RE: **APPROVE THE FINAL DESIGN OF THE FULLER ROAD IMPROVEMENT PROJECT – POTOMAC MAGISTERIAL DISTRICT**

FULLER ROAD (ROUTE 619) IMPROVEMENTS PROJECT FROM JOPLIN ROAD TO QUANTICO MARINE BASE

Location & Design Public Hearing Transcript Documents

Project: 0001-076-995, PE-101, RW-201, C-501

Fuller Road Typical Section—5-Lane Design
(Route 619 to Quantico Marine Base entrance, looking east)

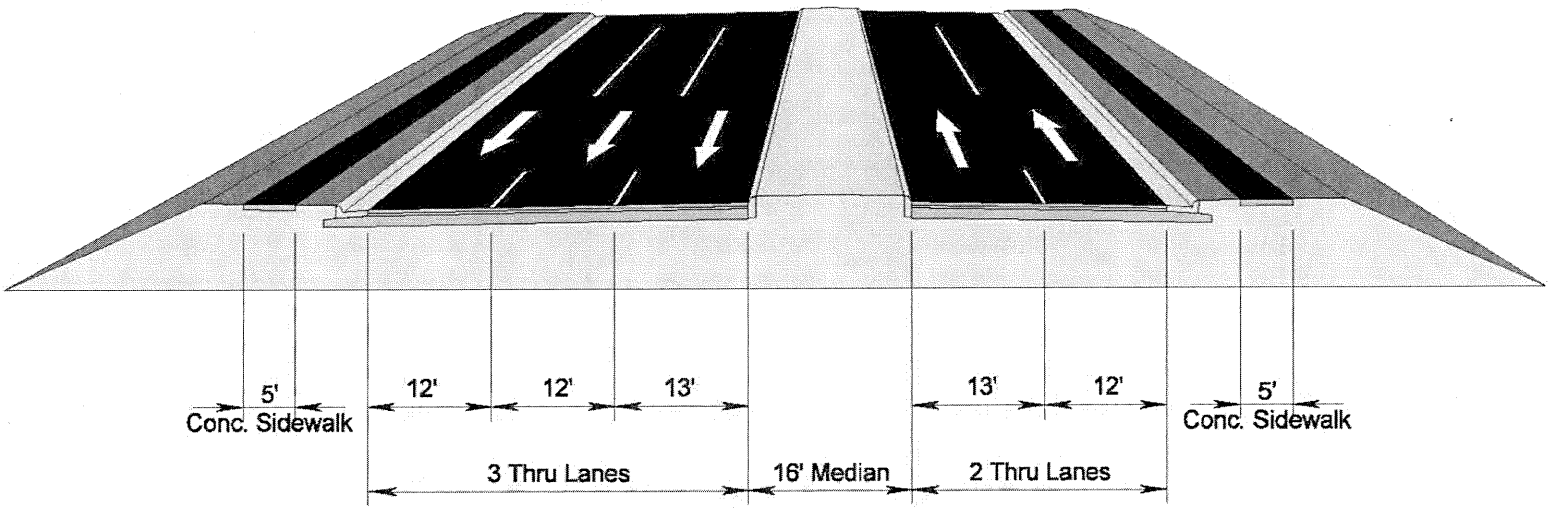
I also noticed in the typical road sections, there are no provisions for sidewalks, no bicycle lanes, or sidewalks on the crossover bridge. I was my understanding, in reviewing the proposed Potomac UDA and discussions with Mrs. Caddigan; this entire UDA was to be a pedestrian/bicycle friendly.

Additional Traffic Lanes on Both Sides of the Crossover Bridge – Based on the approved traffic engineering report, the number of lanes provided meet the projected traffic demands. Providing additional travel lanes as suggested is undesirable due to additional environmental impacts, additional maintenance costs, and potential increased driver confusion. The bridge crossing was optimized to minimize floodplain impacts. Proposed sidewalks are being provided with this project and are being connected to the existing sidewalk along Fuller Heights Road at the proposed cul-de-sac location. Fuller Road and Fuller Heights Road are not currently designated bike routes and therefore do not have proposed designated bike lanes.
